VERMONT YANKEE NUCLEAR POWER STATION

AMENDMENT TO FACILITY OPERATING LICENSE

Amendment No. 120
License No. DPR-28

ATTACHMENT TO LICENSE AMENDMENT NO. 120

Figure 3.6.1 Reactor Vessel Pressure-Temperature Limitations

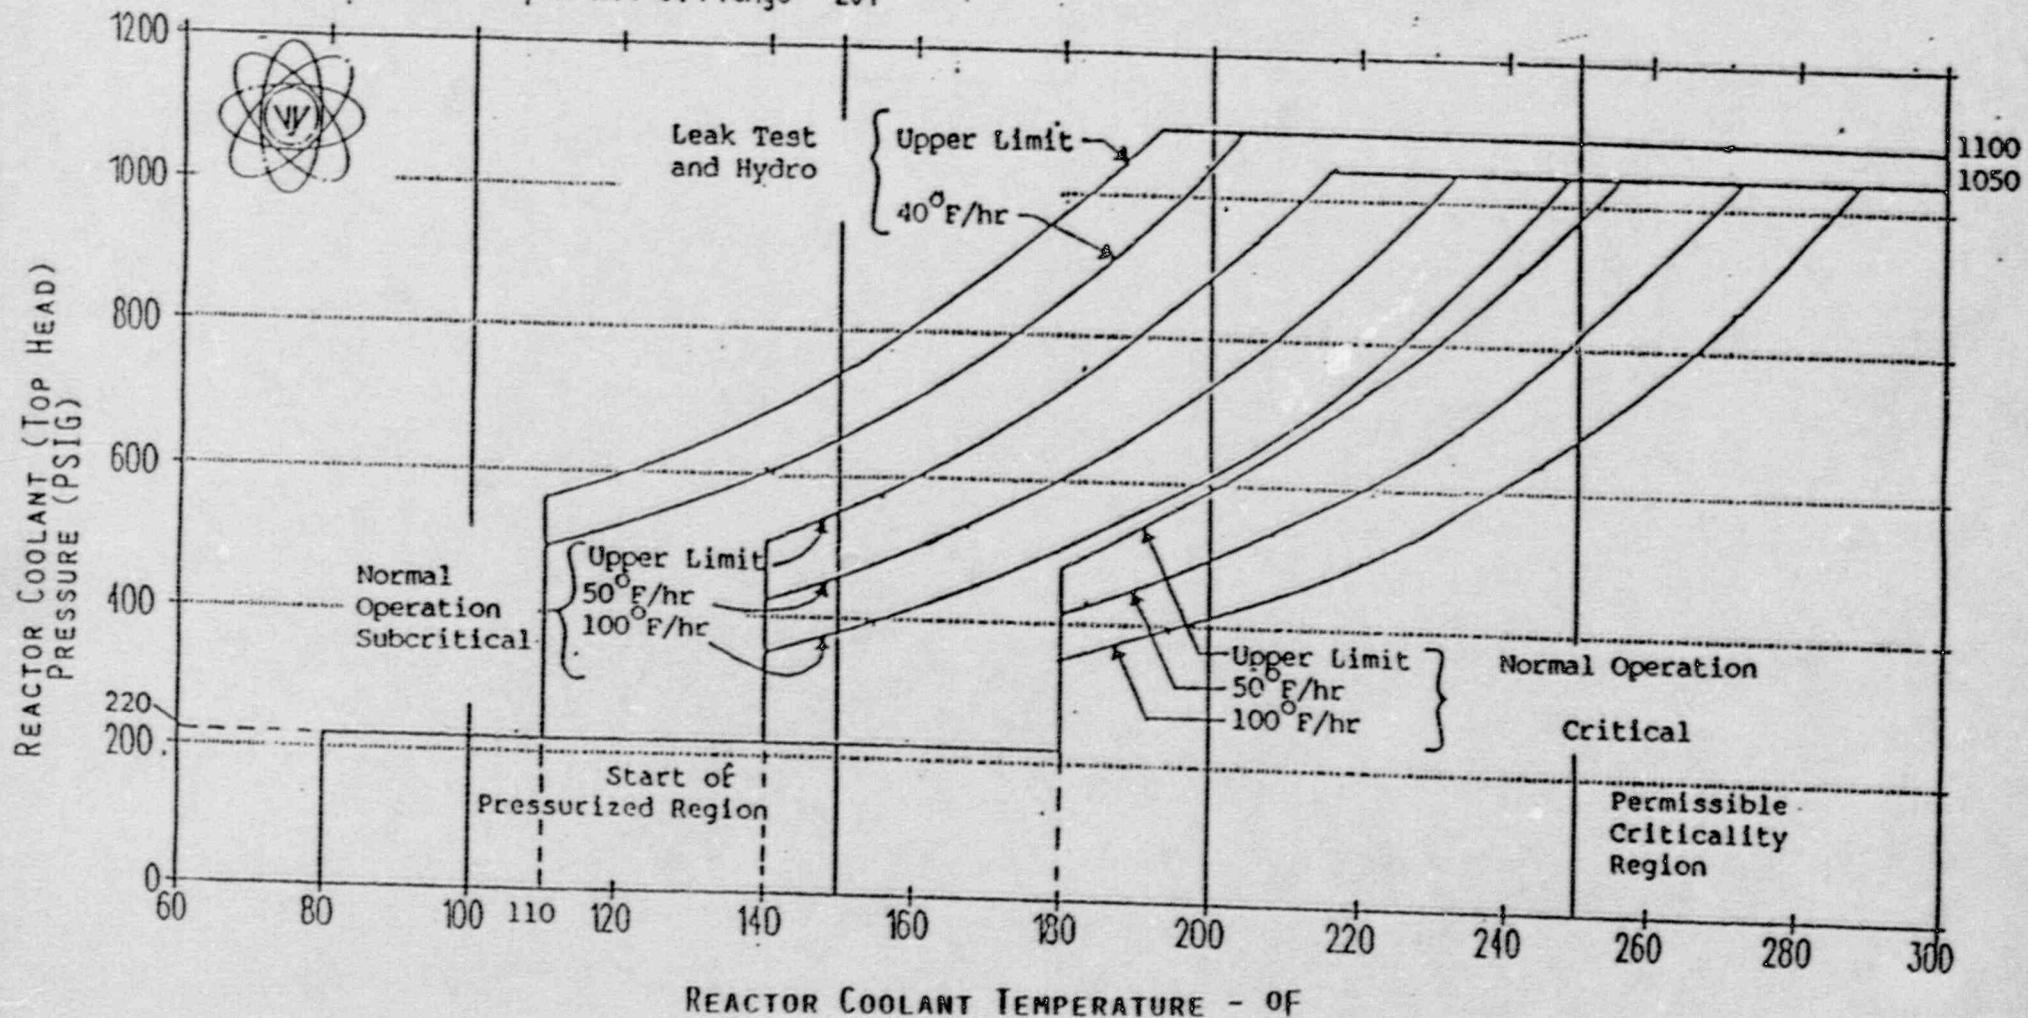
Replace the following pages of the Appendix A Technical Specifications with the attached pages. The revised pages are identified by Amendment number and contain vertical lines indicating the area of change.

Valid Thru 4.46E8 MWH(t) [32 EFPY]

Adjusted Reference Temperature at 1/4T = 89°F
 Adjusted Reference Temperature at 3/4T = 73°F
 Adjusted Reference Temperature at Flange = 20°F

Curves are in accordance with
 10CFR50 App G and RG 1.99 Rev 2
